## CITY OF WACONIA PLANNING COMMISSION AGENDA

<b>Meeting Date:</b>	April 7 <sup>th</sup> , 2016
<b>Item Name:</b>	SITE PLAN and DESIGN REVIEW: Request by Jack Fiedler and Laura Menser for a proposed dental office for the property located at 732 Vista Blvd.
<b>Originating Department:</b>	Planning and Zoning
<b>Presented by:</b>	Angie Perera, Assistant Planner

**Provide recommendation to City Council regarding Site Plan and Design Review for a proposed dental office for the property located at 732 Vista Blvd.**

REVISED REQUEST - 4/7/16  
Planning Commission meeting

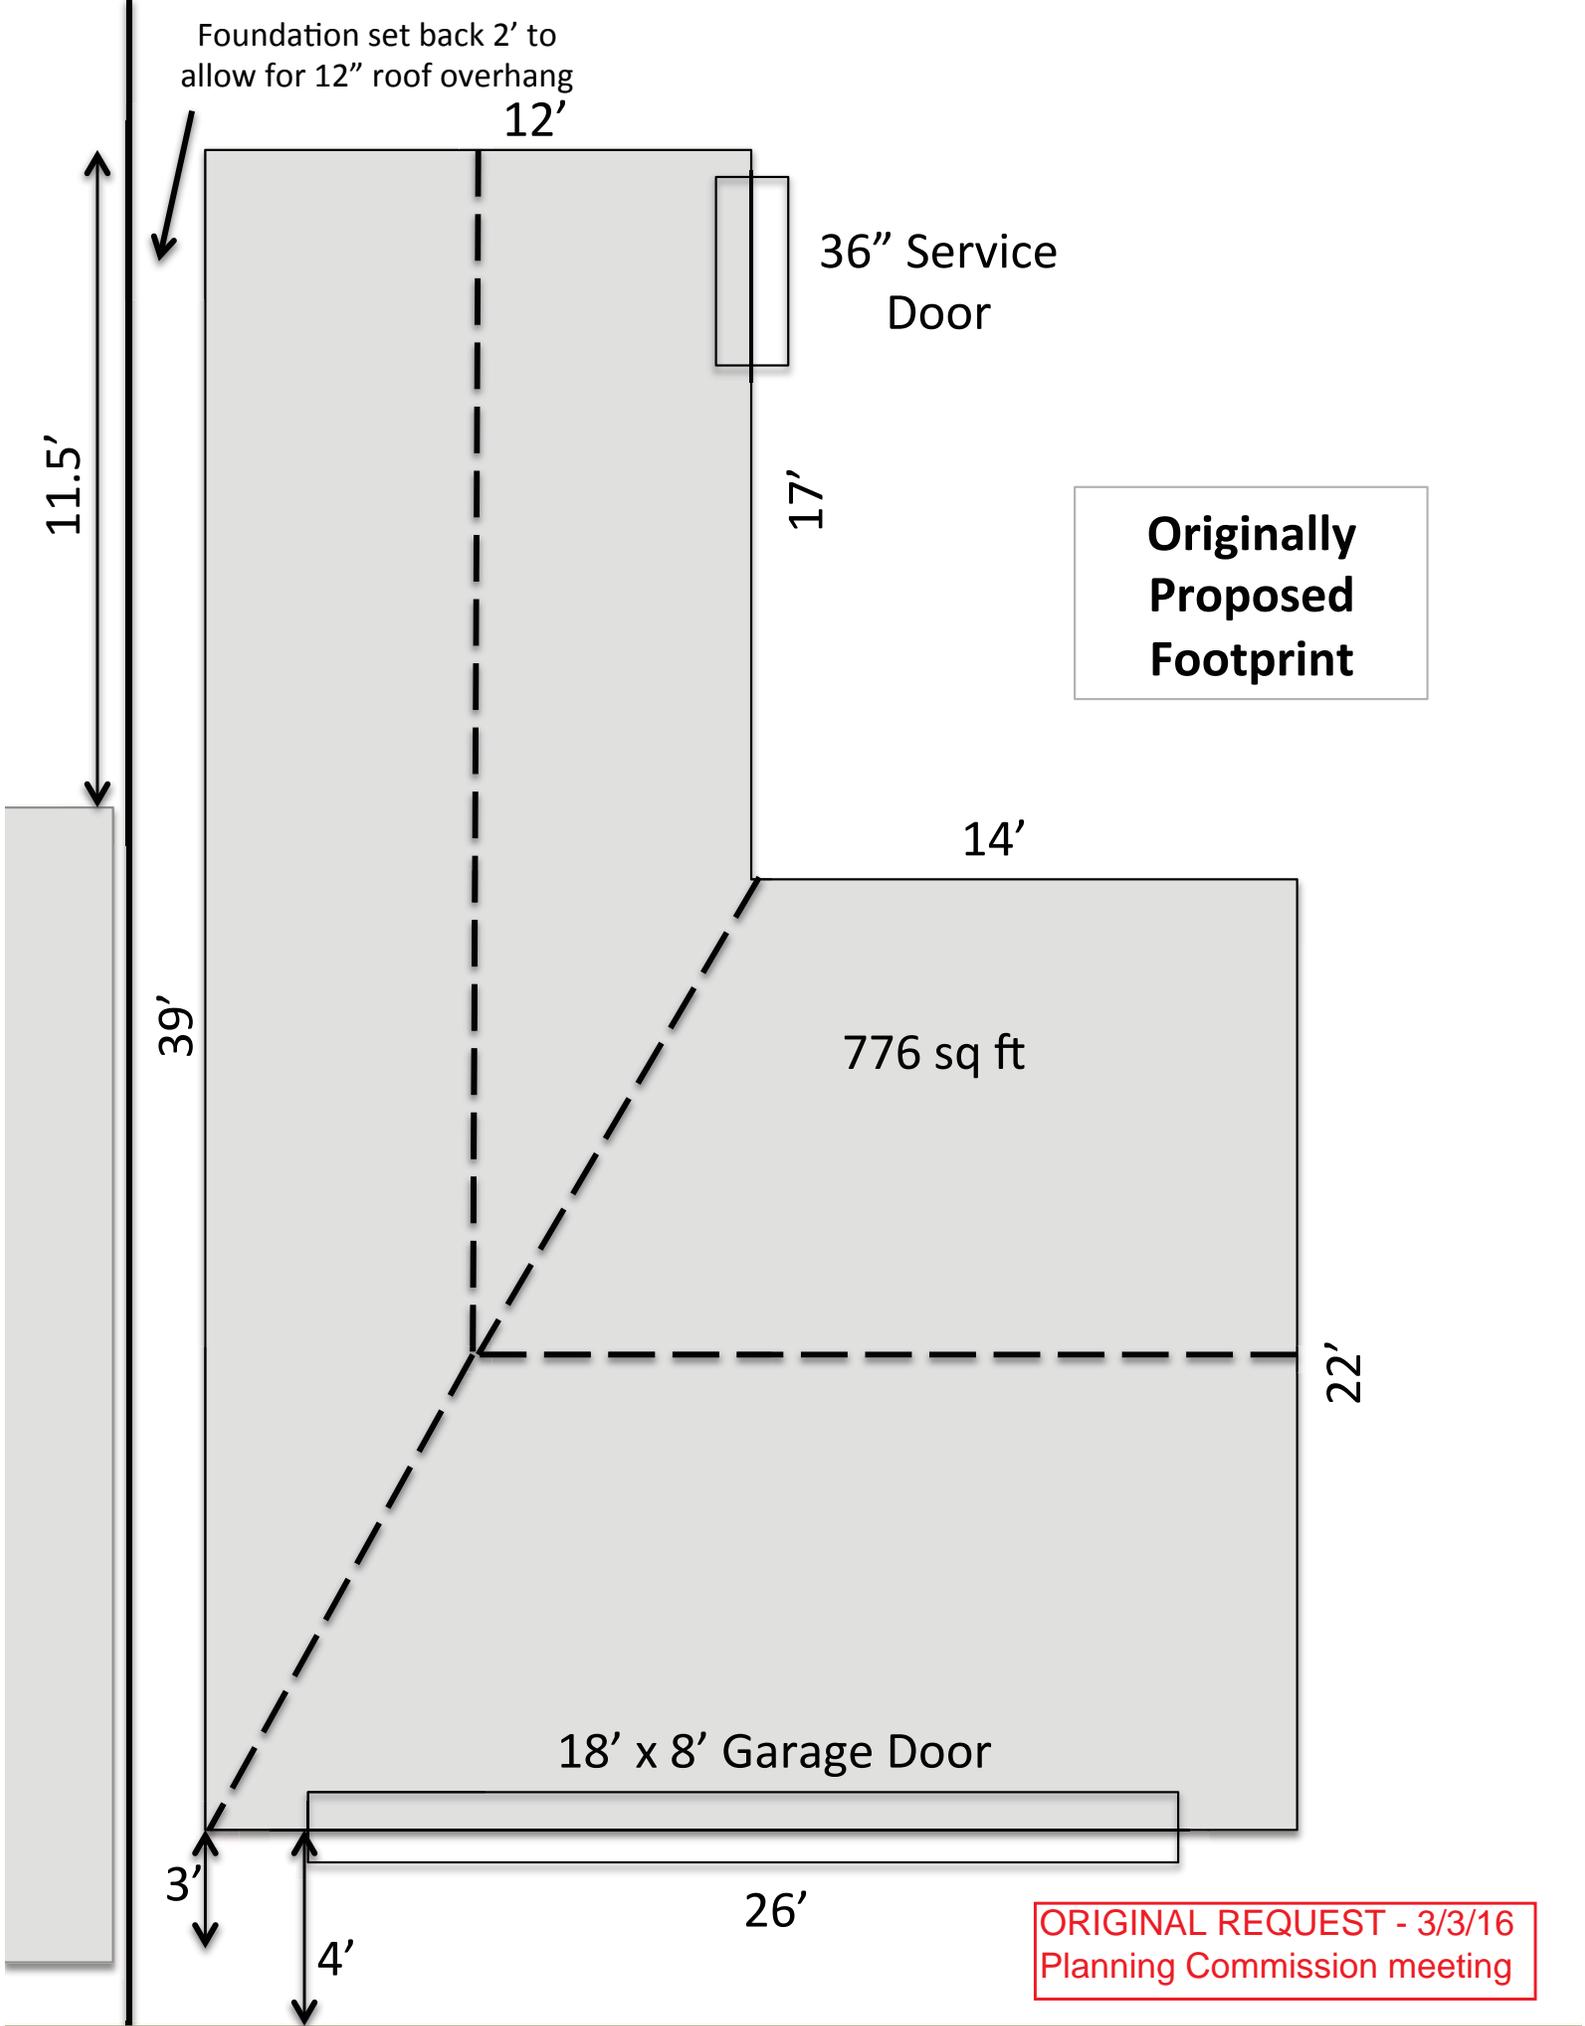
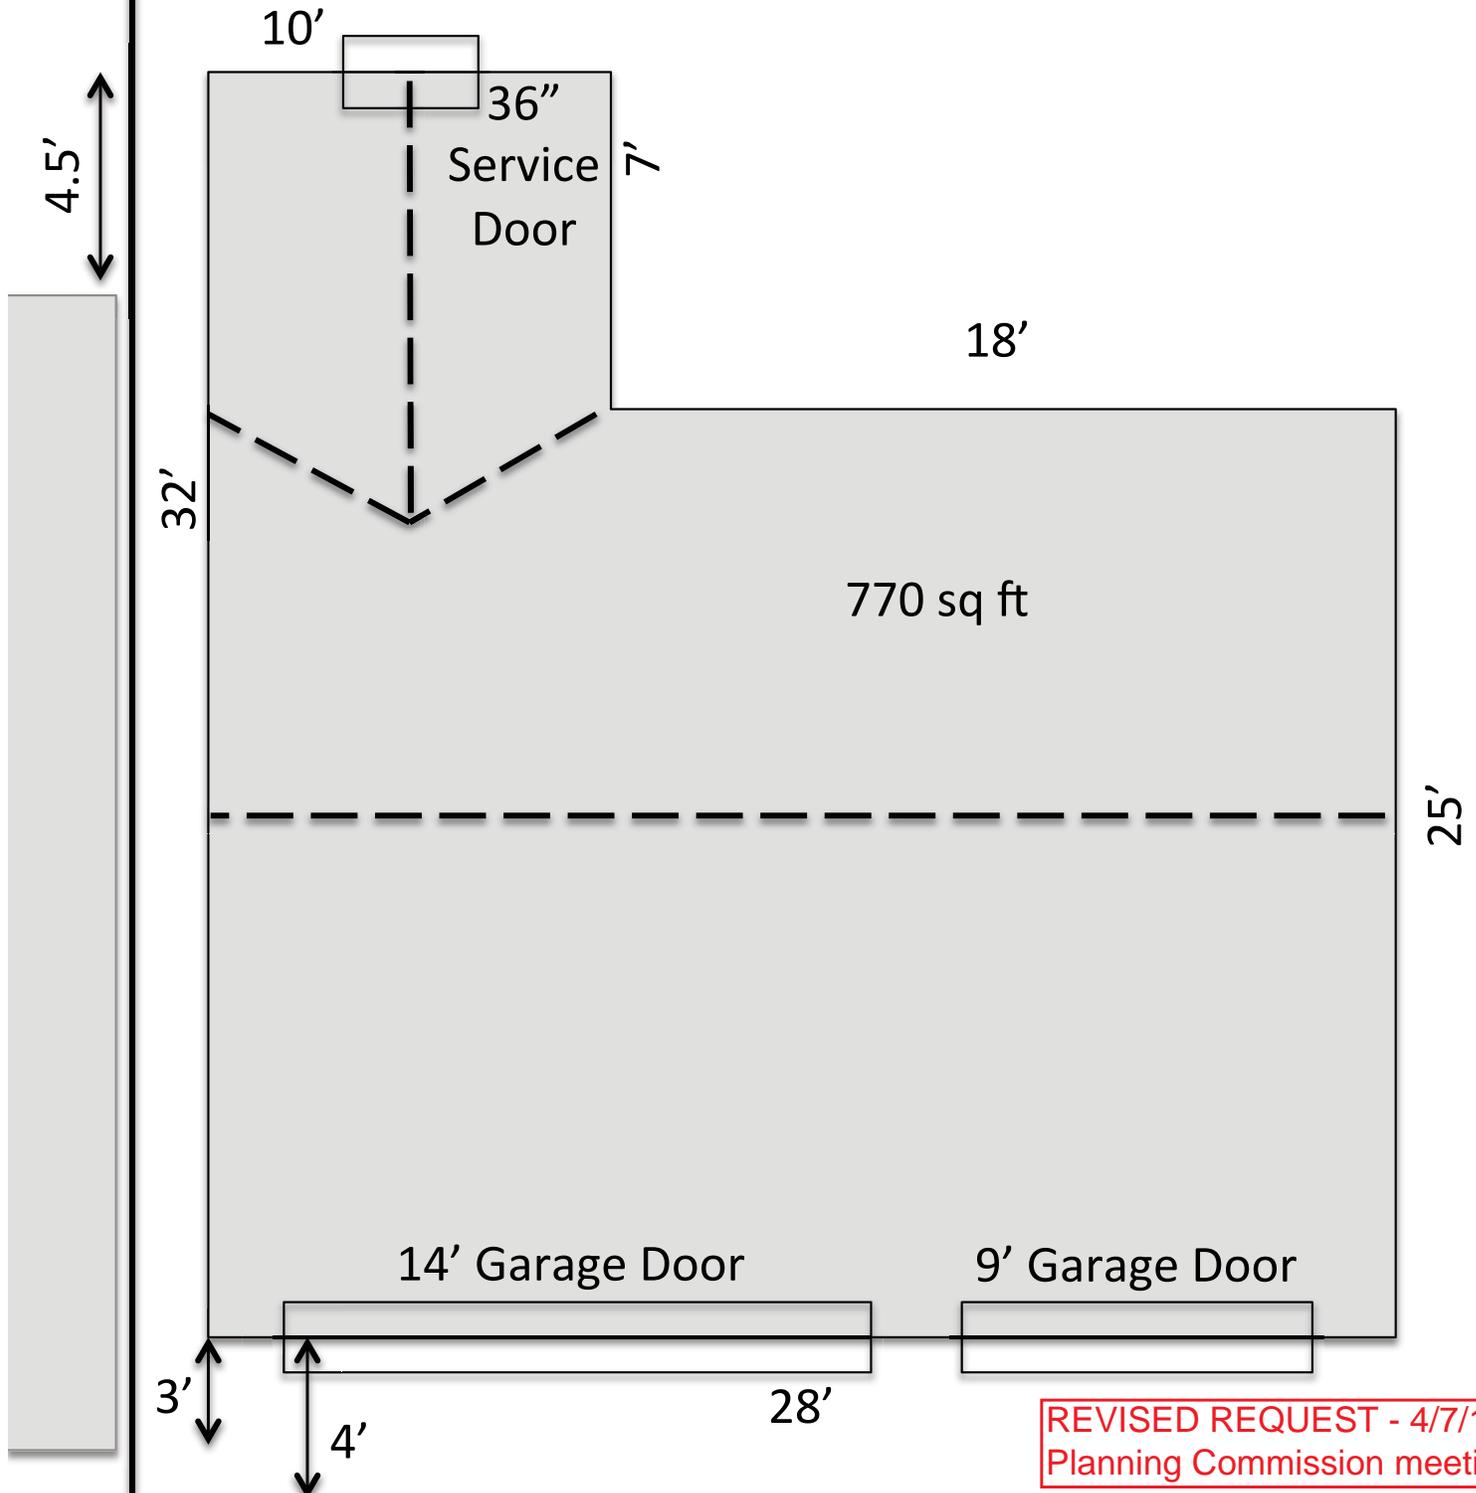
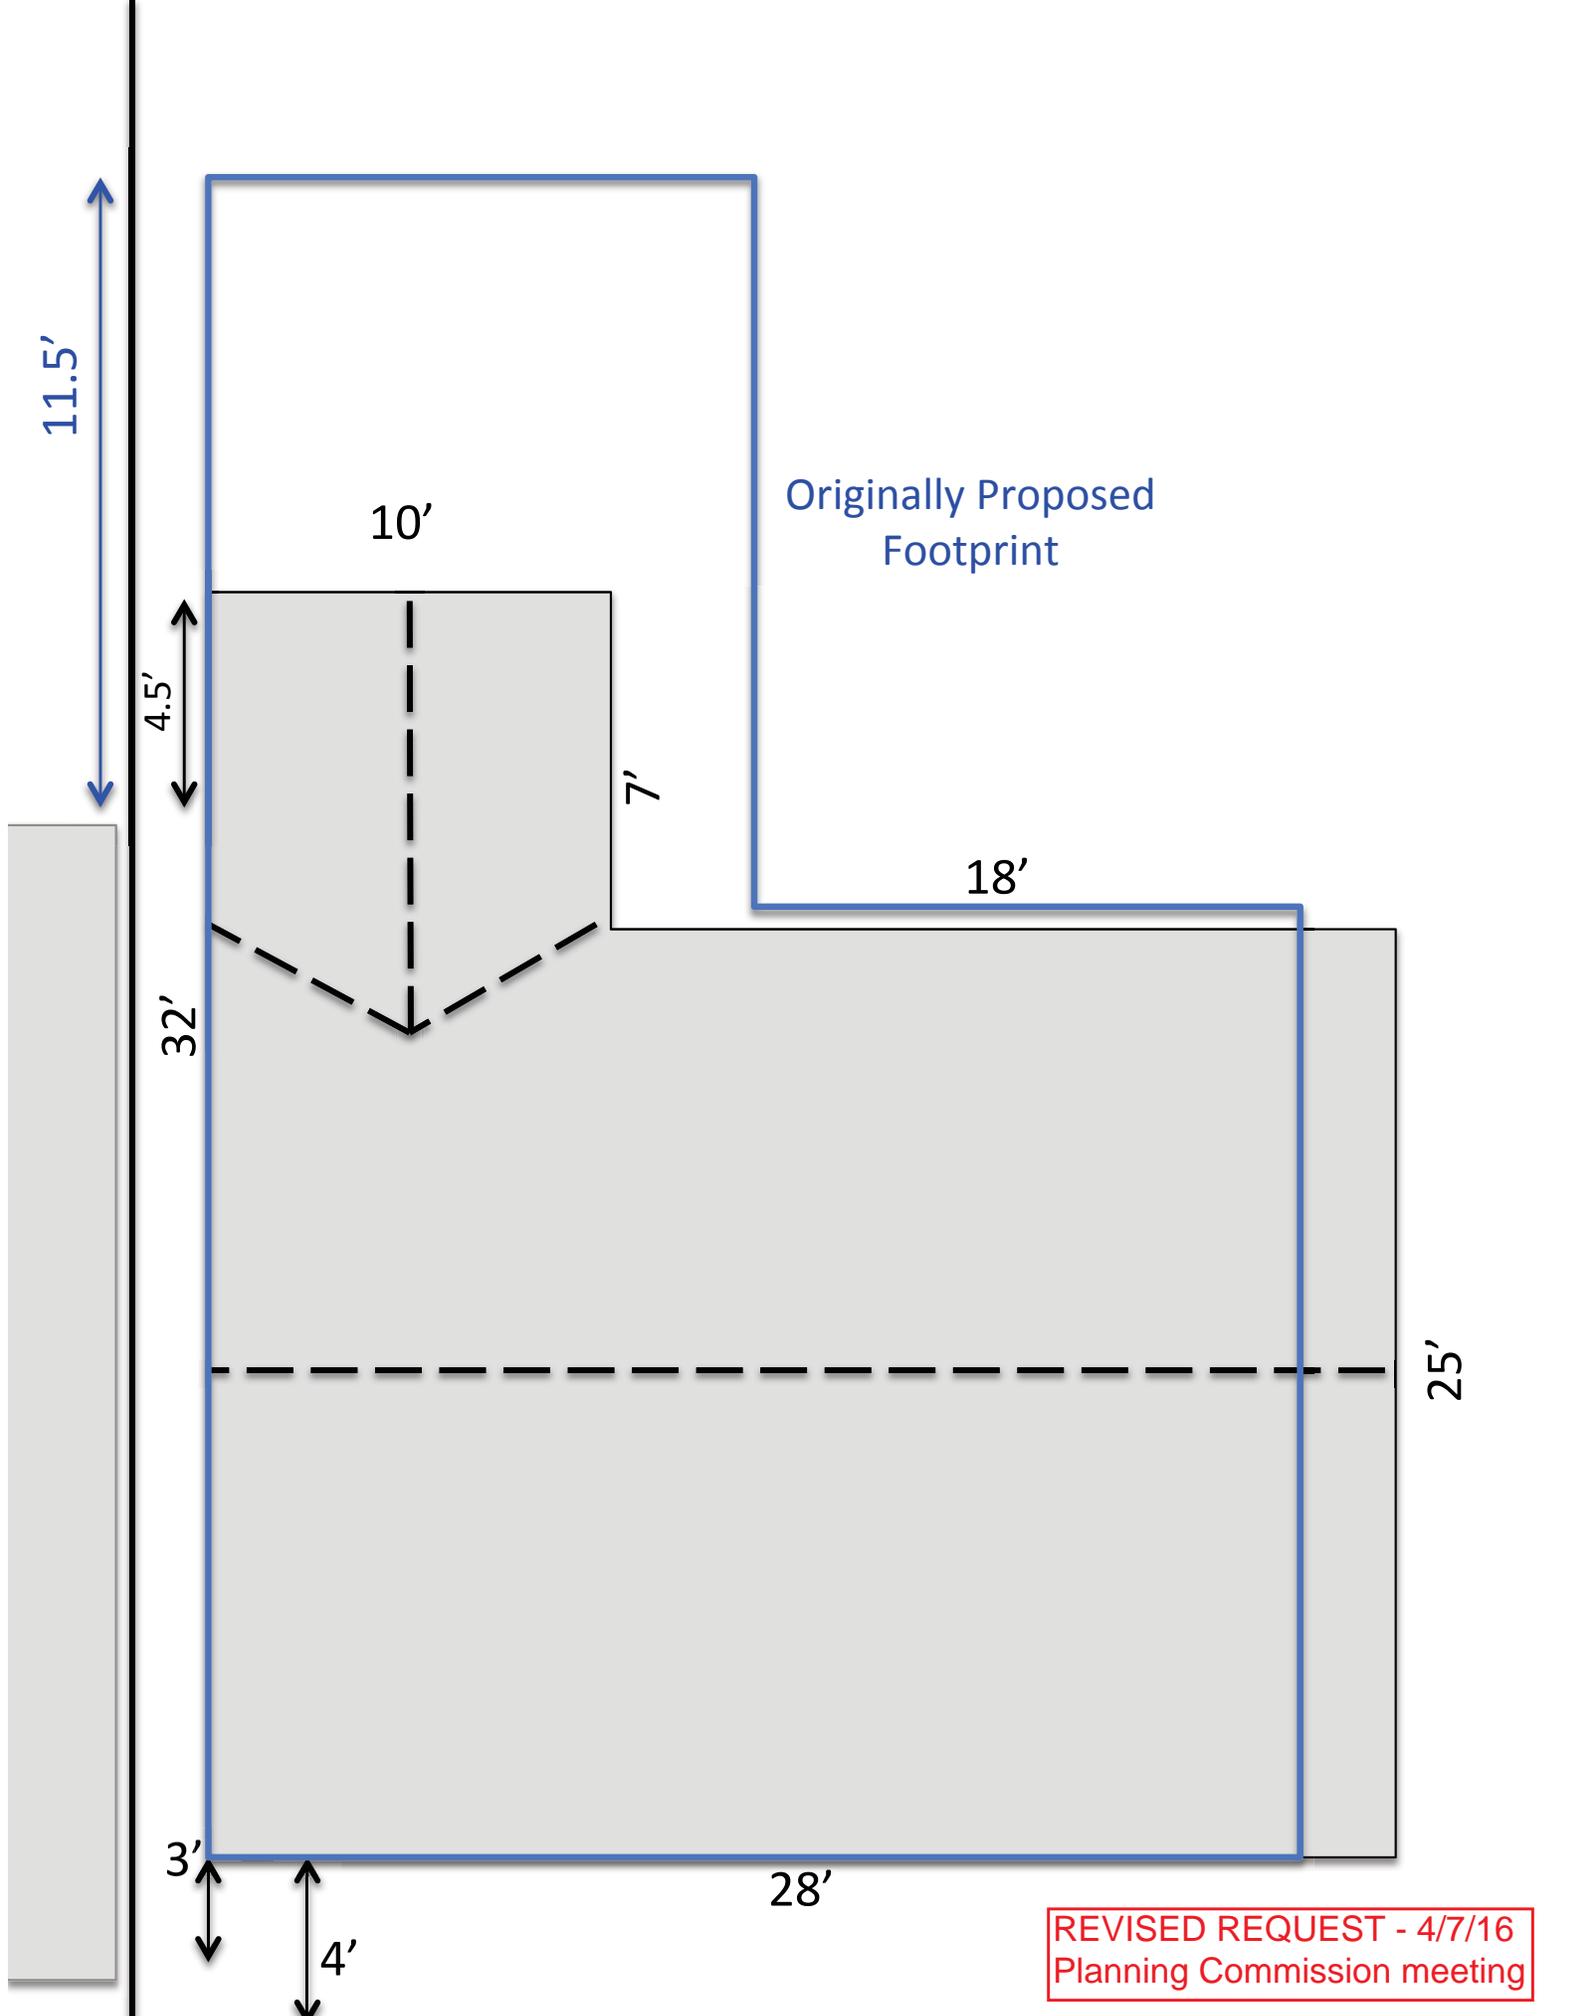
- Previously 11.5', will now extend 4.5' beyond neighbor's garage to the north.

- Total garage area reduced by 6 sqft
- Apron (driveway) to alley widened by 2'
  - Additional 2 sqft impervious (0.02%), essentially unchanged from original proposal
